Re: Minor Project Refinement No. 7 for the South Orange County Reliability Enhancement Project.

South Orange County Reliability Enhancement Project CPUC Minor Project Refinement Form

**MPR-7 Figure 1
Structure Location 12**

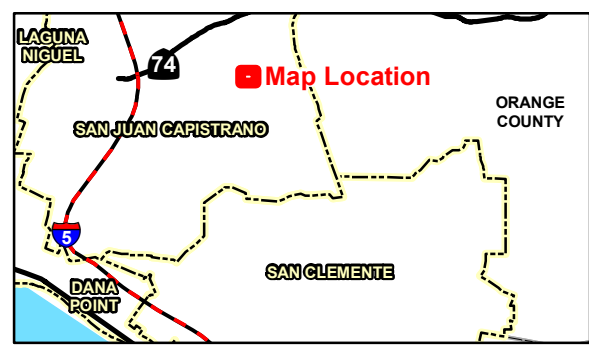
San Diego Gas and Electric (SDG&E) is requesting approval of MPR-7 for a new temporary work area to be used as a turn-around area for the South Orange County Reliability Enhancement Project (SOCRE or Project). The new temporary work area is located adjacent to the access road west of Location 13 and east of existing structure Z198320, previously approved in Notice to Proceed No. 6 (NTP-6). The new MPR-7 work area will total approximately 3,218 square feet (0.07 acre).

The additional work area is necessary to provide safe and practical access to complete construction activities east of I-5, primarily for Locations 11-13. The single-lane access road is too narrow for equipment to turn around, as is the spur road to existing structure Z198320.

MPR-7 is proposing to remove vegetation and perform minor grading along the north and south sides of the spur road in order to provide adequate space for equipment to turn-around, or turn-out to get out of the way from oncoming vehicles. The MPR-7 work area will also be used for temporary staging for concrete trucks or other construction equipment as needed. Portions of fence along the north and south sides of the spur road would be removed during use of the MPR-7 work area and replaced once construction activities are complete.
